**Board of
Zoning Appeals**

Agenda (AMENDED)

Board of Zoning Appeals
Thursday, April 21, 2022

**STAFF REPORT
BOARD OF ZONING APPEALS
APRIL 21, 2022**

Proposed setbacks for zero-lot line development utilizing garage (consistent with P&Z approval in 2021).

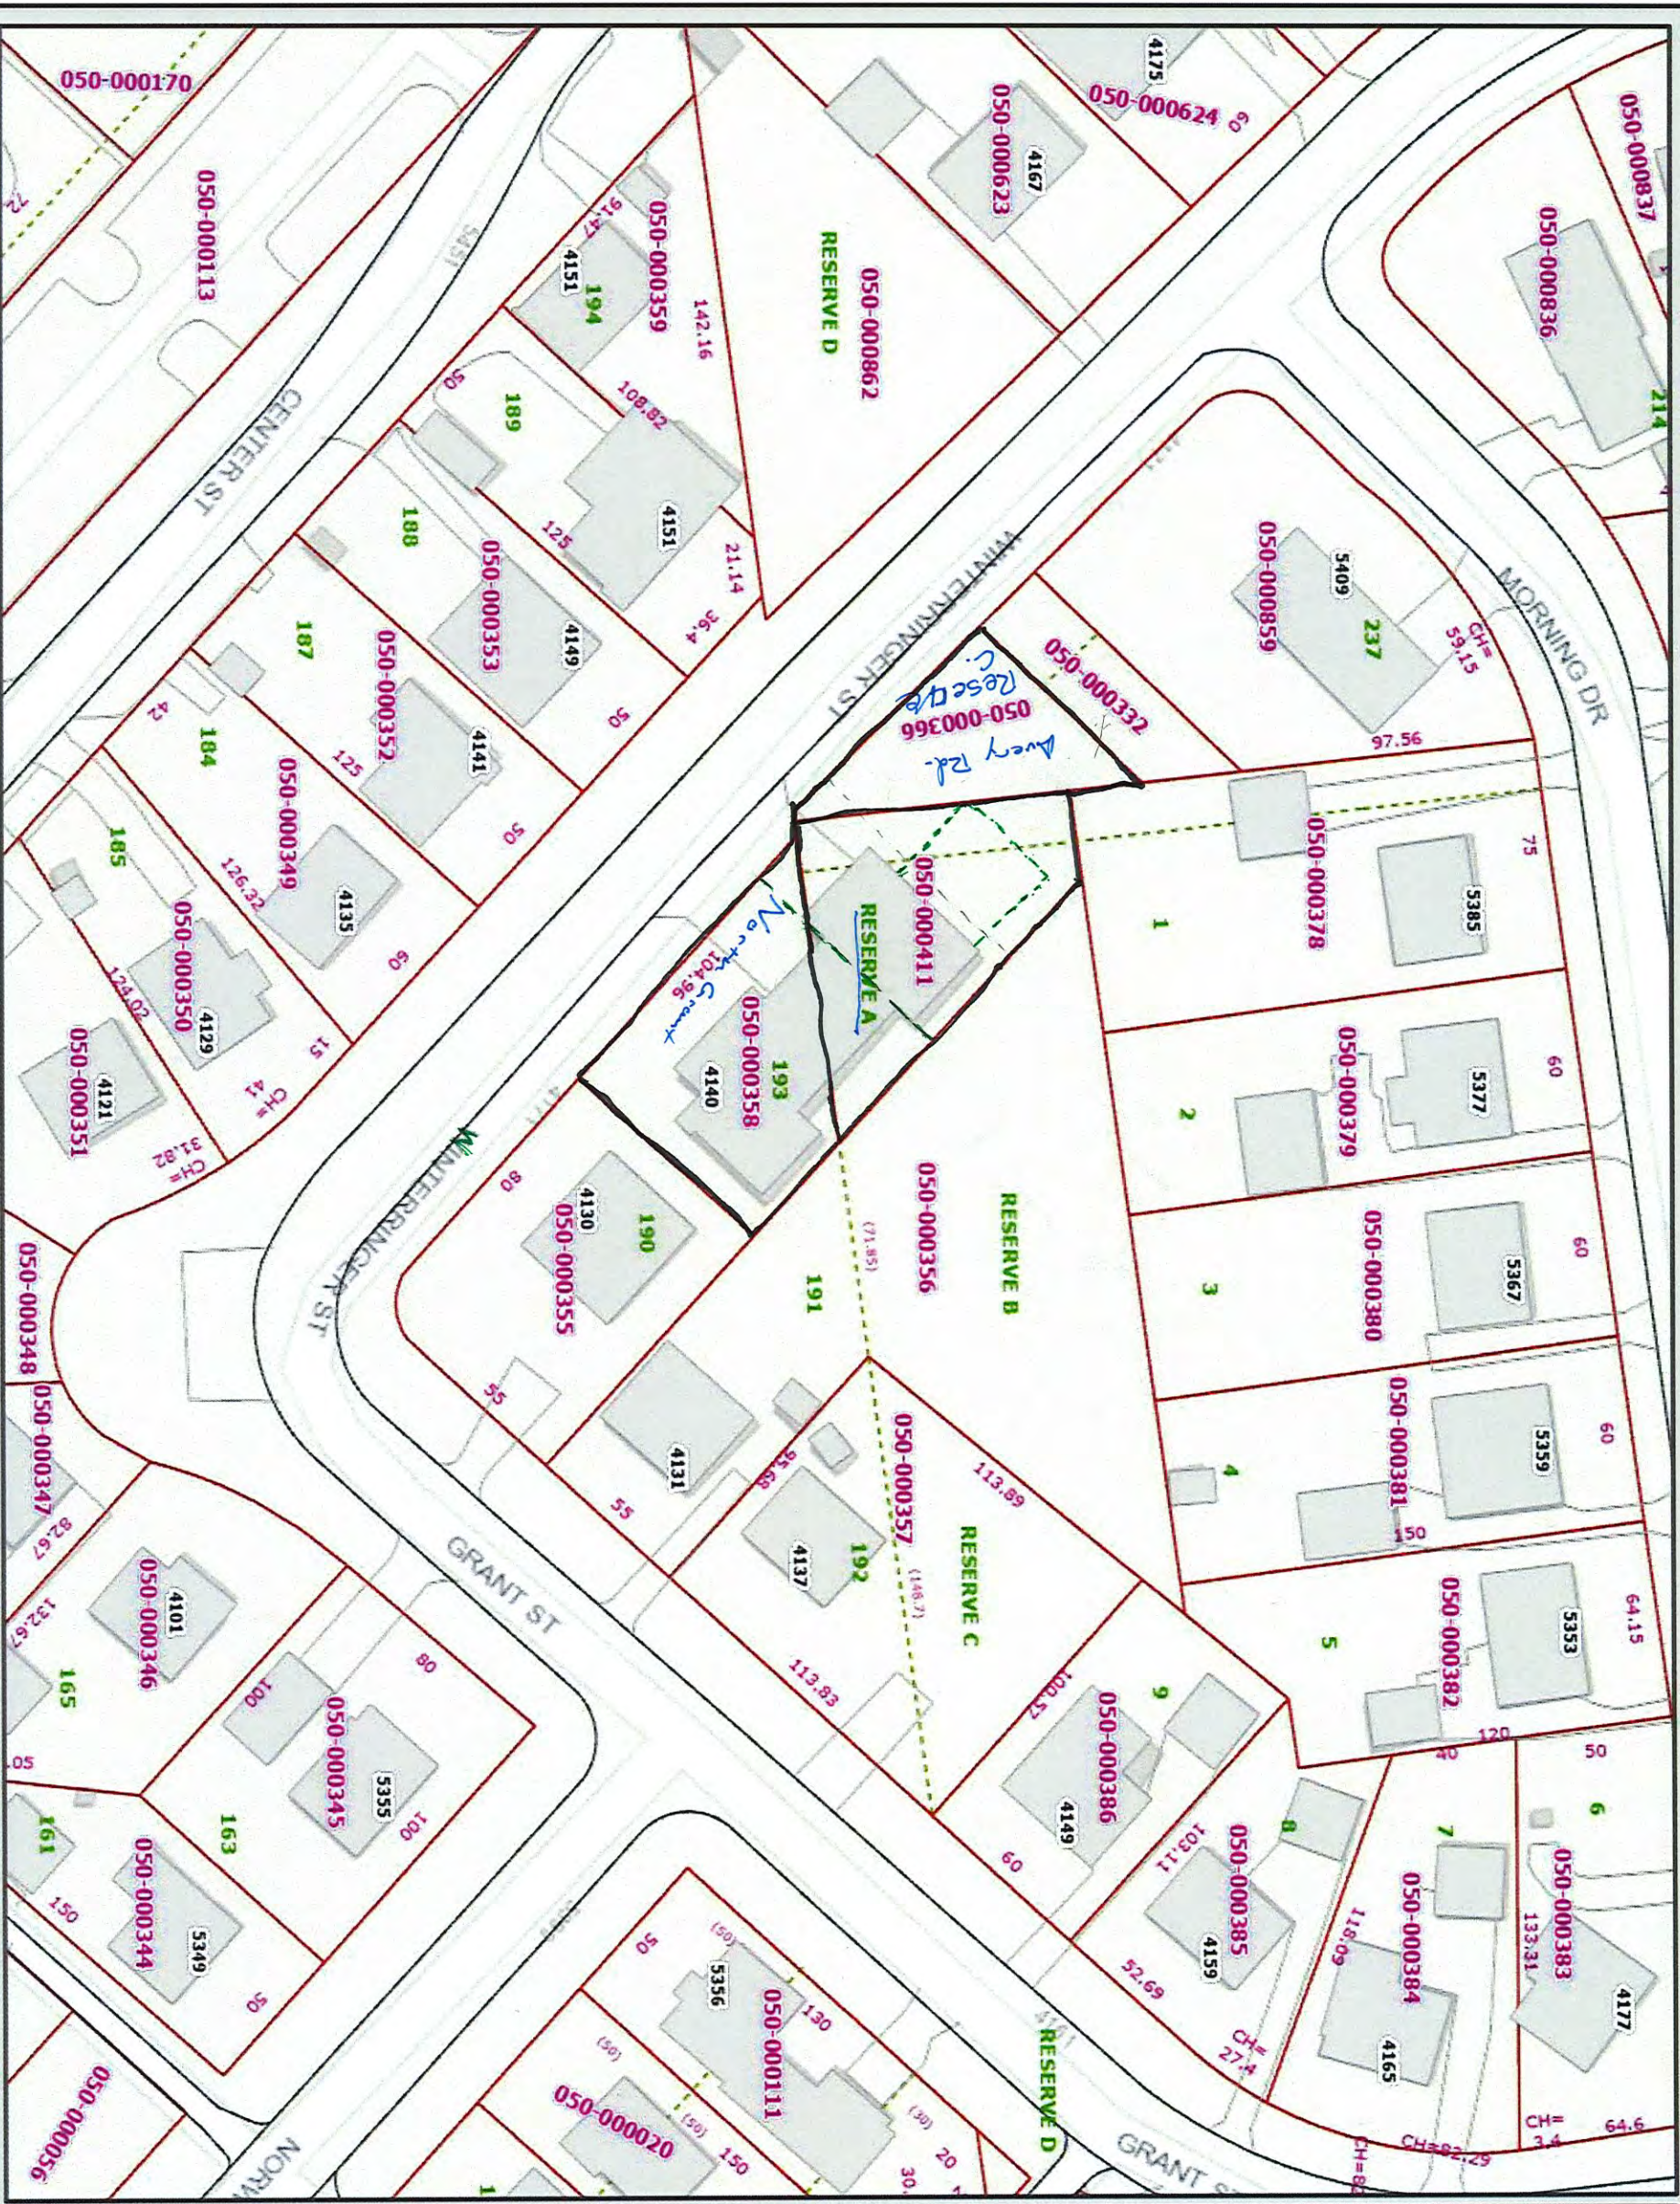
- *Reconsideration.* This request to the Board of Zoning Appeals is to adjust previously approved variances that would support the lot reconfiguration as approved by the Planning and Zoning Commission so both lots include sufficient buildable area.

- 3) Side setback (southeast): 0 feet with location between garages (the BZA previously approved a 2-foot side yard setback).
 - 4) Rear setback: 7 feet as approved by the BZA on October 21, 2021

- 1) That the minimum required rear yard setback for both parcels be seven (7) feet;
- 2) That there be a minimum required side setback of 0 feet between the two parcels;
- 3) That the minimum required side yard setback from the northwestern most property line be 5 feet;
- 4) That the required front yard on the northwestern proposed parcel be 20 feet;
- 5) That legal descriptions and exhibits for both resulting parcels are approved by the City Engineer, recorded and provided to staff prior to the issuance of a zoning certificate;
- 6) That proposed plans/construction adhere to all applicable Building Code provisions with respect to the common firewall between the garages; and
- 7) That a zoning certificate and all required permits be obtained prior to construction;
